**CLOSED
SANITATION INC.
LICENSE NUMBER 291**

SUBJECT: Crowley's request for my review of the Seigmund/Sanitation Inc. hydro. letter dated January 5, 2001

The following is a work plan and sampling protocol amendment for the Sanitation, Inc. landfill in Lewistown, Montana.

RE: SANITATION INC. CLASS II LANDFILL, FERGUS COUNTY – LICENSE NO. 291 GROUND WATER MONITORING –REVIEW OF THE FALL/OCTOBER 2000 SAMPLING EVENT

ATION INC.
own, Montana
te Plan

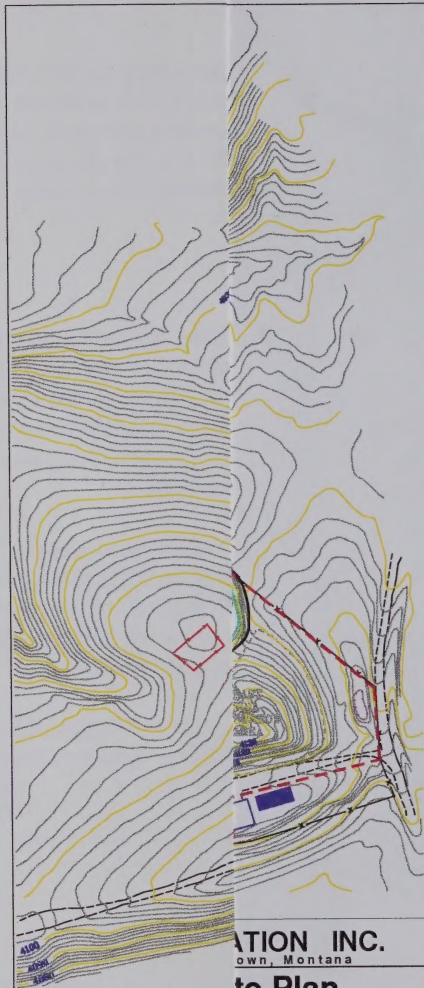
- Proposing to drill 2 new ground water monitoring wells and select only one of the two to sample is odd. Both wells should be monitored for at least 2 years on at least a semi-annual frequency (4 years would be necessary to gather enough data for statistical analysis, i.e., 8 independent samples).

- Sampling both new wells "at the time of drilling" is a waste of money. These new wells should be drilled, completed, and developed. Then after at least a month they could be purged and sampled for the first time. It takes new wells a while (due to drilling methods, aquifer permeability, mobility of some contaminants, etc.) to equilibrate to get a representative sample of the actual aquifer quality.

- If SIMW-1 is not useful as a ground water monitoring well, why bother sampling this well "twice more on a biannual basis starting in 2002" (what exactly does this mean?).
